UNITED STATES
DEPARTMENT OF THE INTERIOR
BUREAU OF LAND MANAGEMENT

SUNDRY NOTICES AND REPORTS ON WELLS
Do not use this form for proposals to drill or to re-enter an abandoned well. Use form 3160-3 (APD) for such proposals.

8. Well Name and No.
FEDERAL BL 1

Chevron respectfully requests to abandon this well as follows:

Federal BL #1 Wellbore Diagram

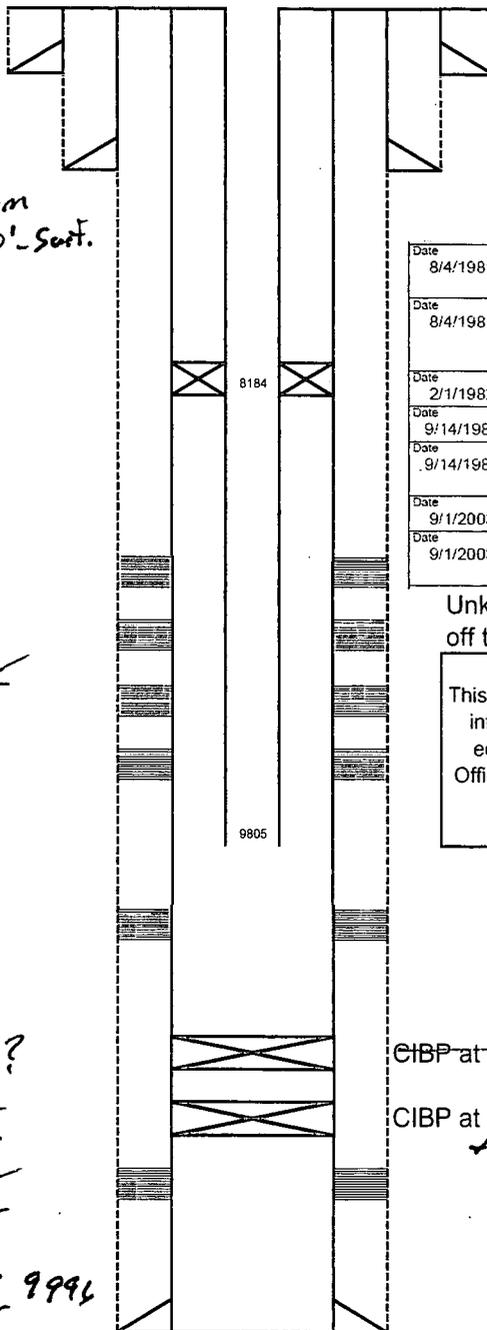
*B.C.M
Del
3418*

*BS
4934*

*WC
7100*

*ST
8982*

*AT
9792*

*MA
10414*

*1" from
120' - Surf.*

CIBP at 10363' *9950 + 35' cmt*

CIBP at 10400' w/ unknown cmt on top *+35' cmt*

Clean out hole to 8614. Set CIBP @ 8614, DWG 35' int on top. IF Perfs exist @ 8305 (?) Set CIBP @ 8255, cap w/ 25 SK.

-omit. GC 11/20/19 Accepted for record - NMOCD

- 7570
7,400' or higher. Discuss w/ BLM about waiving WOC if casing pressure tested. Ensure to spot enough MLF between cement plugs out in accordance w/ BLM regulations. *WOC NOT Req. Need 25 sx Spacer 6360-6280.*
8. Perforate casing at 3,842' & squeeze 55 sx CL "C" Cement f/ 3,652' t/ 3,842', WOC & tag (Bone Spring). Must tag at 3,692' or higher. *Add. Shoe plug: Part @ 2483, 502 cont to 2363. WOC Tag.*
9. Perforate casing at 1,662' & squeeze 220 sx CL "C" Cement f/ 930' t/ 1,662', WOC & tag (Cherry & Brushy Canyons). Must tag at ~~970'~~ or higher. *1420*
10. Perforate casing at 453' & squeeze 140 sx CL "C" Cement f/ Surface t/ 453' (FW, shoe). *1420*
11. Cut off wellhead 3' below grade, Verify Cement To Surface, install required dry hole marker as per COA's, turn over to reclamation.
- All cement plugs will be class "C" (<7,500') or "H" (>7,500') with a closed loop system used.
